NOTICE OF DEVIATION PURSUANT TO 10 CFR 21

Subject: NPKC-7-21A(N) Splice kit with possible compromised jacket seal

2. USING THIS ILLUSTRATION:

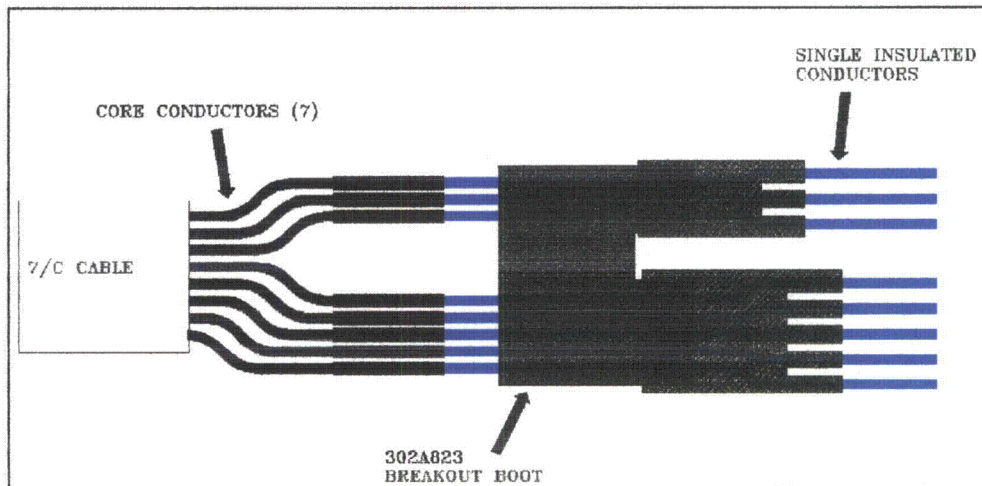
TE Connectivity Energy division has determined that when the Raychem brand splice kit NPKC-7-21A(N) was created, an incorrect breakout boot was selected as part of the kit. As a result, the jacket sealing properties of the splice kit may be compromised when the kit is installed on single insulated conductors that have an outside diameter less than 0.18 inches.

From the list above, item 5 should be described as 302A834-52-0-N not 302A823-52-0-N. As a result, the jacket sealing properties of the splice kit may be compromised when the kit is installed on single insulated conductors that have an outside diameter less than 0.18 inches. Please note, if each the seven core conductors have an outside diameter no smaller than 0.11 inches, then the seven individual conductor splices are still insulated, sealed and protected and therefore not part of this notification. The only functional attribute at issue is the seal of the cable jacket. If the jacket of the seven conductor cable is not considered part of the Environmental Qualification requirement or is not "qualified", then it may be determined that no corrective action, other than documentation, is necessary.

Determine if any splices were installed on single insulated conductors that have an outside diameter less than 0.18 inches.

2.1. If NOT, then the installed splices are still insulated, sealed and protected and therefore no corrective action or replacement is required.

2.2. If YES, Determine whether or not the cable jacket or the cable jacket seal is required for Environmental Qualification.

2.2.1. If YES, the splices should be removed and replaced. Notify TE Connectivity for replacement. (Telephone 800-327-6996)

2.2.2 If NOT, then verify the diameter of the seven core conductors to be greater than 0.11 inch. If they are equal to or greater than 0.11 inches, then the seven individual conductor splices are still insulated, sealed and protected and therefore not part of this notification. If they are less than 0.11 inches, the splices should be removed and replaced. Notify TE Connectivity for replacement. (Telephone 800-327-6996)
